Report of the Working Party on Pollution and Energy on its sixty-first session (11-14 January 2011)

Amendments to Regulation No. 83 adopted by GRPE on the basis of GRPE-61-19

Annex 4, paragraph 6.1.3., amend to read:

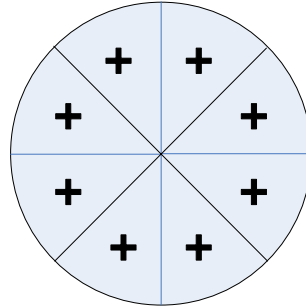
"6.1.3. A current of air of variable speed shall be blown over the vehicle. The blower speed shall be within the operating range of 10 km/h to ~~at least 50 km/h, or as an alternative, at the request of the manufacturer, within the operating range of 10 km/h to~~ at least the maximum speed of the test cycle being used. The linear velocity of the air at the blower outlet shall be within ± 5 km/h of the corresponding roller speed within the range of 10 km/h to 50 km/h. At the range over 50 km/h, the linear velocity of the air shall be within ± 10 km/h of the corresponding roller speed. At roller speeds of less than 10 km/h, air velocity may be zero.

- (a) For blowers with rectangular outlets are located at the centre of each rectangle dividing the whole of the blower outlet into 9 areas (dividing both horizontal and vertical sides of the blower outlet into 3 equal parts). **The centre area shall not be measured (as shown in the diagram below).**

- (b) For circular blower outlets, the outlet shall be divided into 8 equal arcs by vertical, horizontal and 45° lines. The measurement points lie on the radial centre line of each arc (22.5°) at a radius of two thirds of the total (as shown in the diagram below).

Annex 4a, paragraph 3.4.2., amend to read:

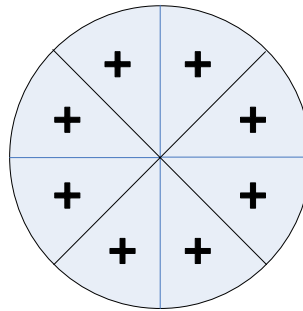
- (a) For blowers with rectangular outlets are located at the centre of each rectangle dividing the whole of the blower outlet into 9 areas (dividing both horizontal and vertical sides of the blower outlet into 3 equal parts). **The centre area shall not be measured (as shown in the diagram below).**

- (b) For circular blower outlets, the outlet shall be divided into 8 equal arcs by vertical, horizontal and 45° lines. The measurement points lie on the radial centre line of each arc (22.5°) at a radius of two thirds of the total (as shown in the diagram below).
